**IN THE MATTER OF
NATIONAL ENERGY BOARD
HEARING ORDER GH-003-2015
NOVA Gas Transmission Ltd.
TOWERBIRCH EXPANSION PROJECT**

AFFIDAVIT OF DONOVAN CAMERON

Saulteau First Nations written submission
for the proposed
TransCanada's Towerbirch Pipeline in North Eastern British Columbia

NATIONAL ENERGY BOARD
Hearing Order GH-003-2015
NOVA Gas Transmission Ltd. ("NGTL")
Towerbirch Expansion Project
OF-Fac-Gas-N081-2015-16 02

APPENDIX "B"

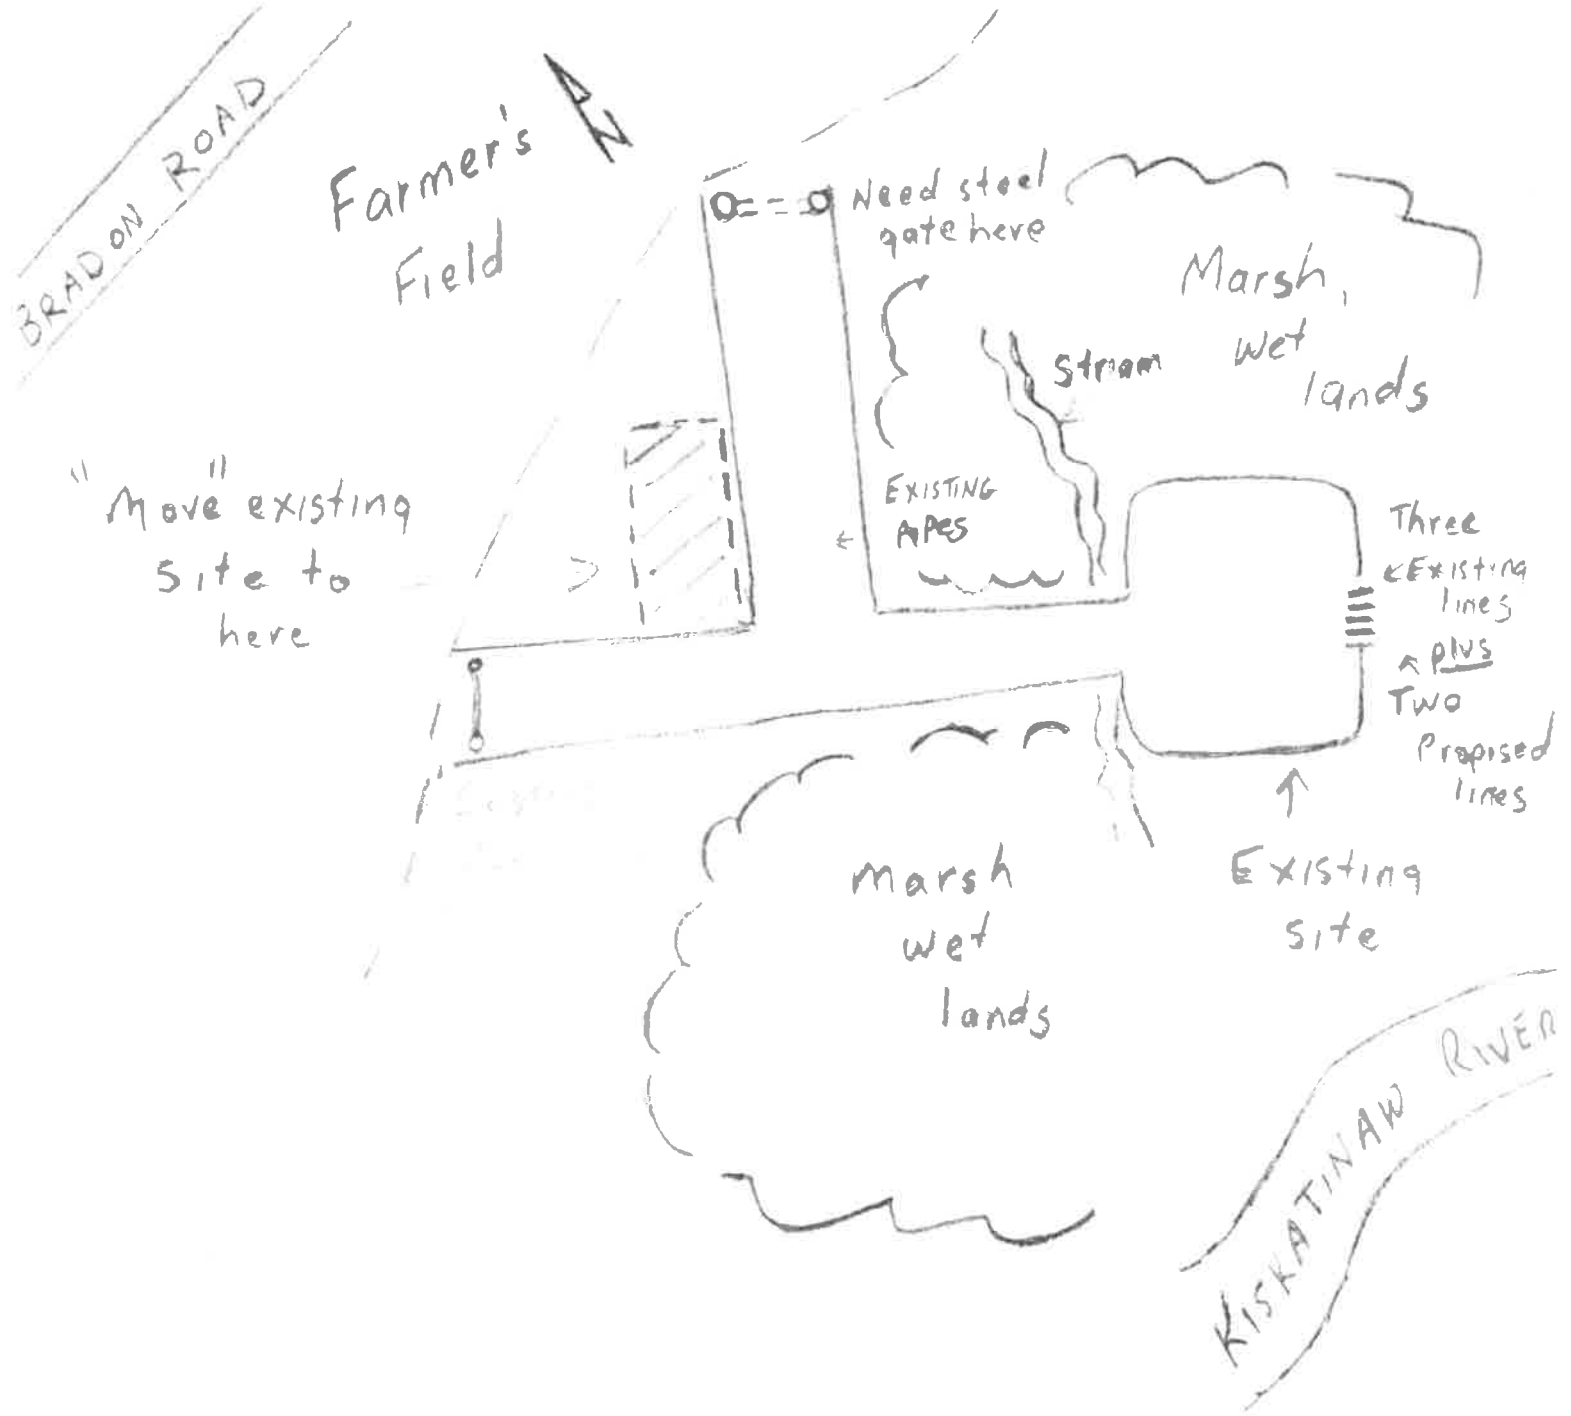
I can see horizontal drilling that is needed and about 30 meters more that needs to be cleared, my recommendation is to move this site still farther north (drawing attached, Appendix B) and away from the wet lands, it's a filtering system that needs to be protected. THE MAIN CONCERN HERE, IS THAT THE BANKS OF THE KISKATINAW RIVER ARE UNSTABLE AND MUST BE BORED FARTHER UP NORTH. Even farther than where is now proposed.

This wildlife corridor needs to be protected, we should not bother the animal shelter, strong mitigation measures needed, less impact more protection for the wildlife. We recommend that there be a steel gate to block off all access for sports hunting or hunting period, should save this area from further destruction, there is already one steel gate there, but one more would do just fine.

Response:	<p>Please see the map attached as Appendix "A" for the location of each of the aforementioned sites.</p> <p>In addition to this map, the following are the GPS coordinates for each of the above sites:</p> <ul style="list-style-type: none"> (a) Assumed site of existing bore/drill location: 55.951, -120.6723; (b) SFN proposed drilling and bore area: 55.9535, -120.6766;

location that is as close to the River as SFN deems acceptable. SFN's preference, however, would be to move the bore/drill site even further from the River than the location proposed by SFN.

Additionally, SFN seeks to have another gate (Gate 2) installed on the north side of the River, to reduce access to and disturbances of the wetland area. As noted above, this area is extremely sensitive.

Finally, SFN seeks to have the existing gate (Gate 1) maintained, for all of the reasons provided in respect of Gate 2.
